BCA 2019.1 AND ACCESS INDICATIVE COMPLIANCE REPORT FOR DA ASSESSMENT

10-11 Railway Street

Werrington NSW

Prepared for:	George Wehbe
	C/- Level Architects
Project No.:	20-0175
Date:	20/09/2021
Status:	lssue v 2.0

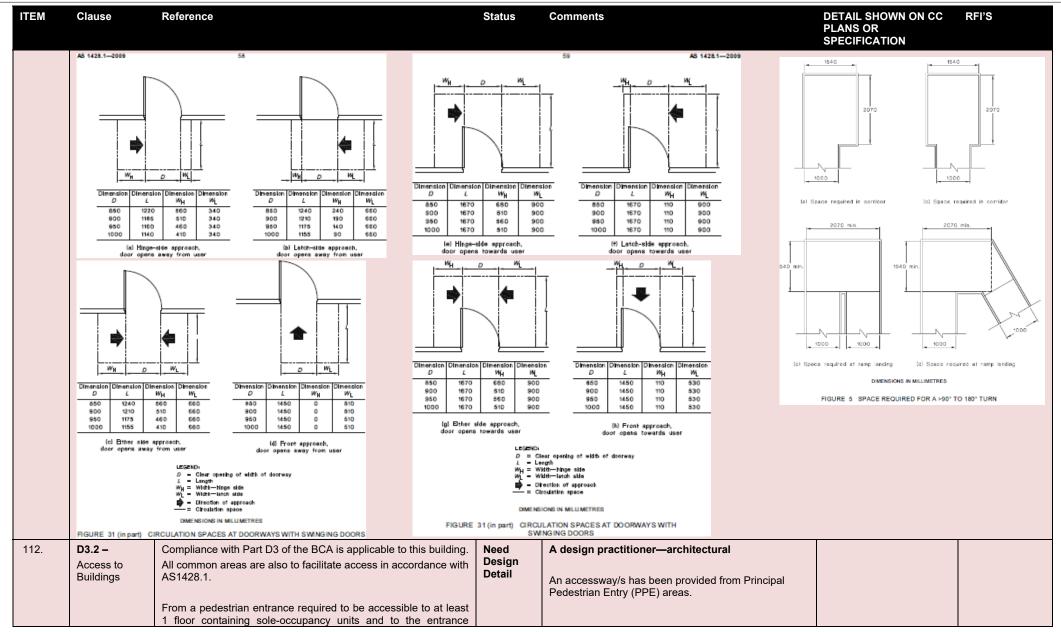
Numerous doorways to common facilities throughout the basement and residential floor levels and the doorways to thecommercial loading dock and sanitary facilities on the ground floor leve appear not to meet the set dimensions under AS 1428.1 and/or are provided with less than 850mm clearance through the active door leaf. Please note: D3 requires access just to the SOU door, not within the unit unless the unit is Adaptable.								
	Compliance	e can be achieved by slight redesign or alter	natively in some cases via an access	performance solution conducted prior to issue of the	Construction Certificate.

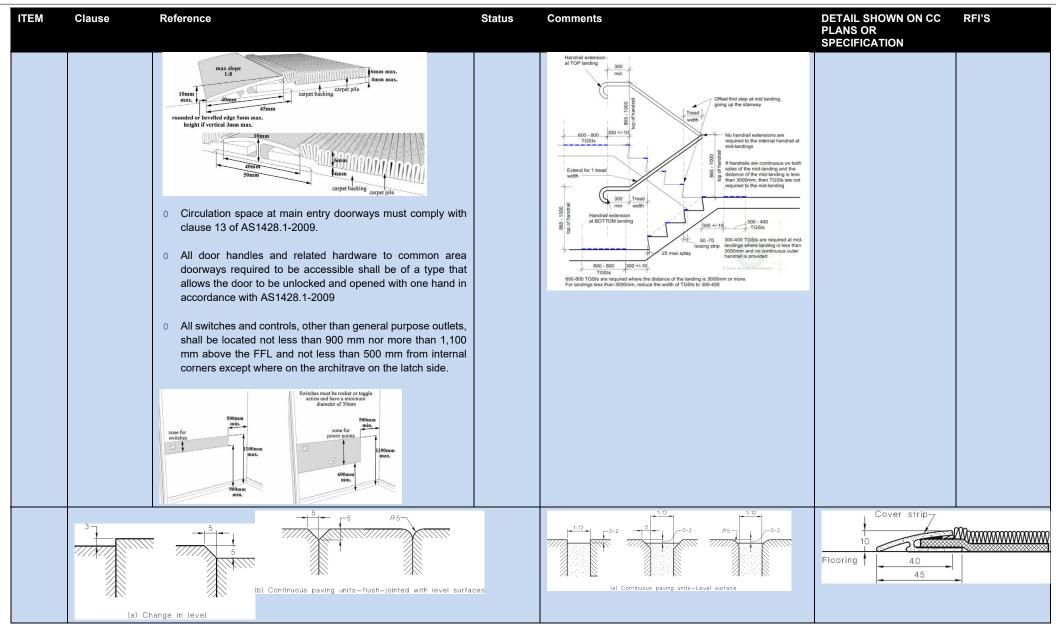
ITEM Clause	Reference	Status	Comments	DETAIL SHOWN ON CC PLANS OR SPECIFICATION	RFI'S
113. D3.3 - Parts of Buildings to be accessible	<text><list-item><list-item><list-item><list-item><list-item></list-item></list-item></list-item></list-item></list-item></text>	CRA	 A design practitioner—architectural Walkways and ramps must comply with clause 10 of AS 1428.1-2009. Non-fire-isolated stairways must comply with Clause 11 of AS 1428.1-2009. Fire-isolated stairways must comply with clause 11 (f) & (g) of AS 1428.1-2009. Accessways must have passing spaces (1800 mm x 2000 mm) complying with AS 1428.1-2009 at maximum 20 m intervals on those parts of an accessway where a direct line of sight is not available. Accessways must have turning spaces (1540 mm x 2070 mm) within 2m of the end of the accessway and at maximum 20 m intervals along the accessway. Note: Turning spaces must be provided clear of fixtures and fittings such as skirtings, general purpose outlets (GPOs), fire extinguishers etc. An intersection of accessways satisfies the spatial requirements for a passing and turning space. Note: The Access to Premises Standards to not provide the concessions provided in sub-cluses (g) and (h) in this clause, hence compliance with the Access to Premises Standards will require the floor covering in the accessible areas to strictly comply with Clause 7.4.1(a) of AS1428.1-2009. Please advise as to which apartments are to be adaptable. Plans Not provided. Final details to be provided detailing floor services and materials are to be provided at the Construction Certificate stage or noted on the plans.

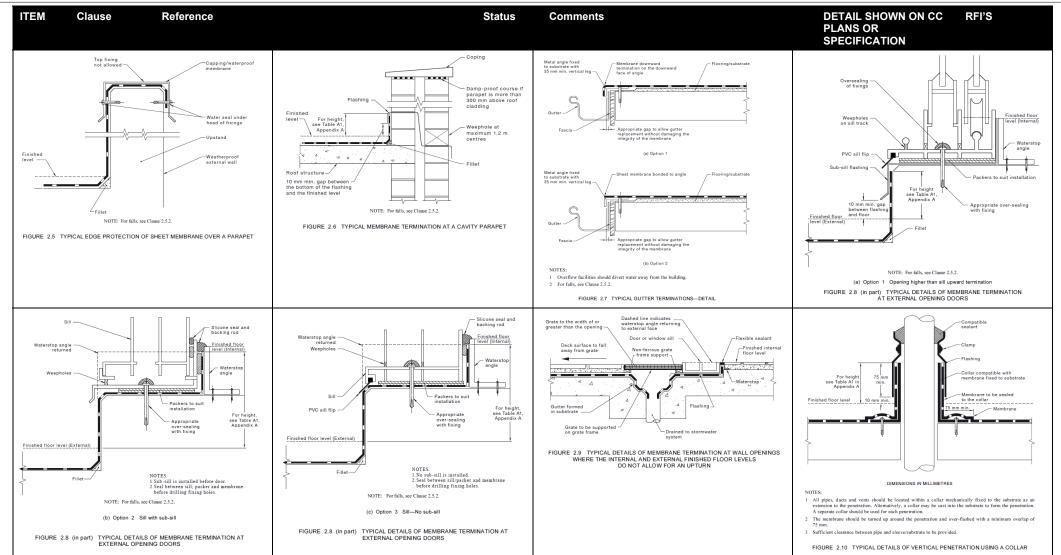
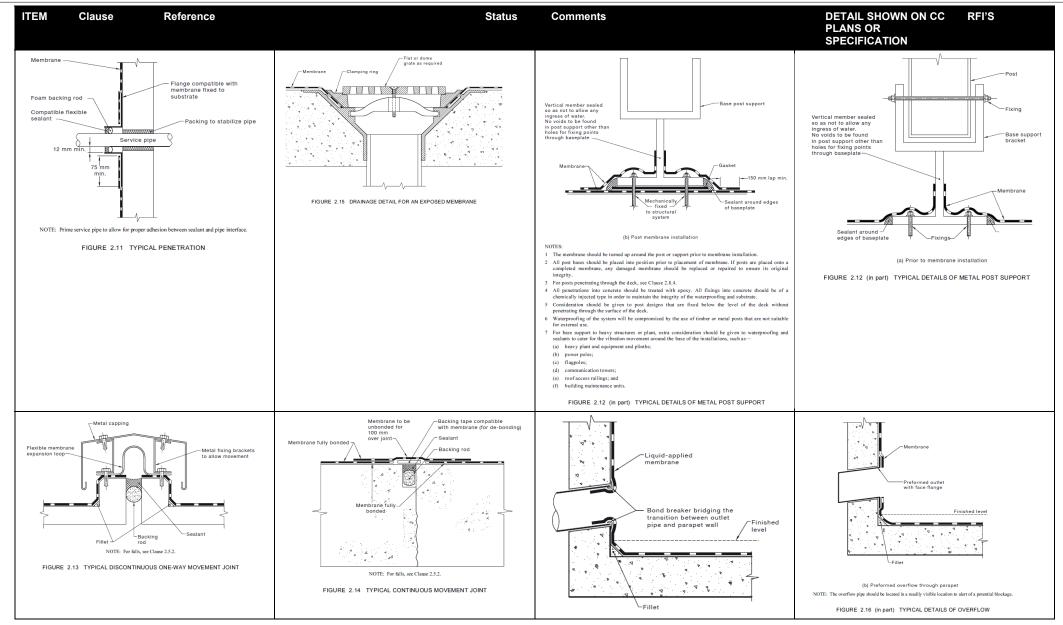
157.	F1.2 –	-		-	No provisions		
158.	F1.3 –	-		-	No provisions		
159.	F1.4 – External above ground membranes	Waterproofing membra comply with AS4654 Pa	nes for external above ground use to arts 1 and 2-2012.	CRA	A design practitioner—architectural Details and a design certificate will be required by a suitably qualified hydraulic engineer prior to the issue of a Construction Certificate.		
Weathergroof external wait for height, for		MINATIONDETAIL OF	For height, see Table At Appendix A For Sealant For height, see Table At Appendix A For fails, see Class 2.5.2 DIMENSIONS IN MILLIMETRES FIGURE 2.3 TYPICAL VERTICAL UPWARD TERMINATION—DETAIL SEAL FOR SHEET MEMBRANE	Finished level	Sheet membrane	(b) Optional balcony edge detail for a fully

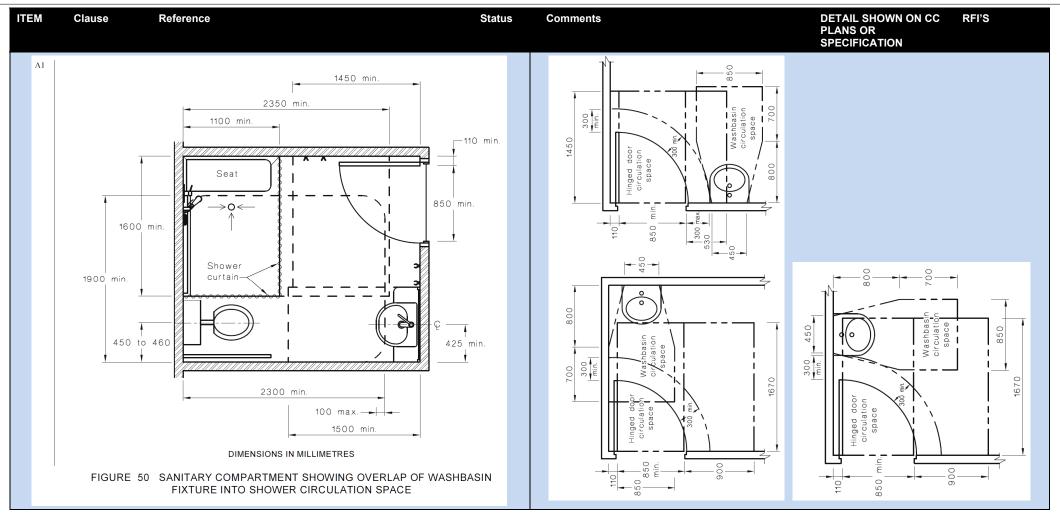
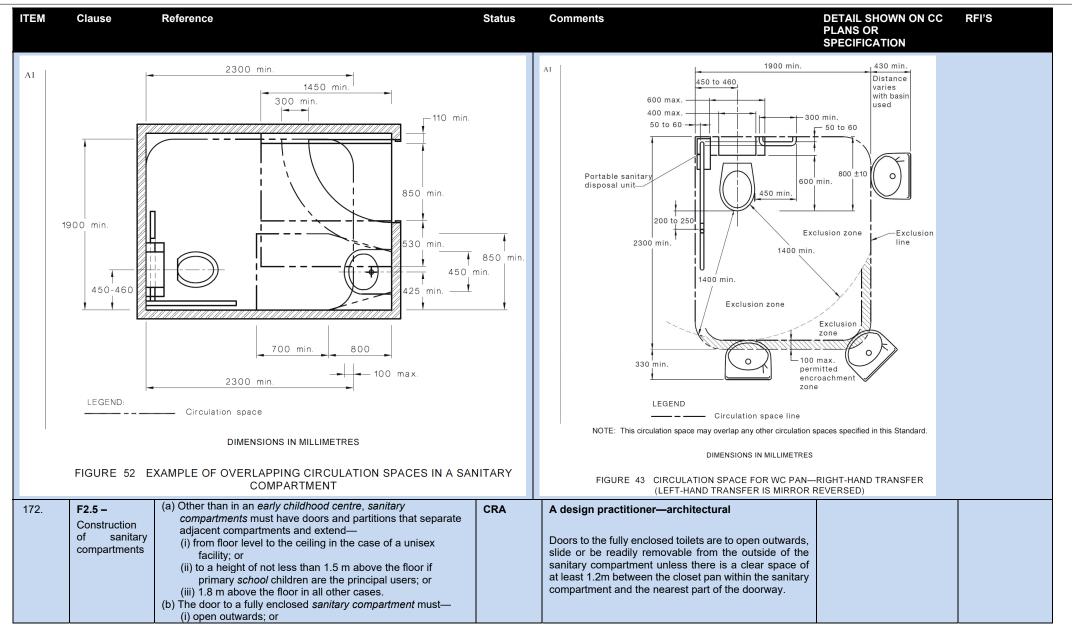
171.	F2.4 – Facilities for people with disabilities	accorda required	ible unisex sanitary ance with Table F2. d to be accessible. Th s and the standard, A).	4(a), in buildings on e details for the prov	r parts that are vision of disabled	CRA	Final c	gn practitioner—a limensions of acces nstruction Certificat	sible facilities are red	quired at			
			Table F2.4(a) Acc	essible unisex	sanitary comp	artments							
			Class of buildin	g			Minimun be provi		isex sanitary cor	npartme	ents to		
						· · · · · · · · · · · · · · · · · · ·				1 10	1		
	Class 3 and Class 9c						sanitary occupan (b) at ead and fema	compartments wi cy unit, not less t ch bank of <i>sanita</i>	ble-occupancy uni ithin the accessible than 1; and any compartments partments provide	le sole- containii	ng male
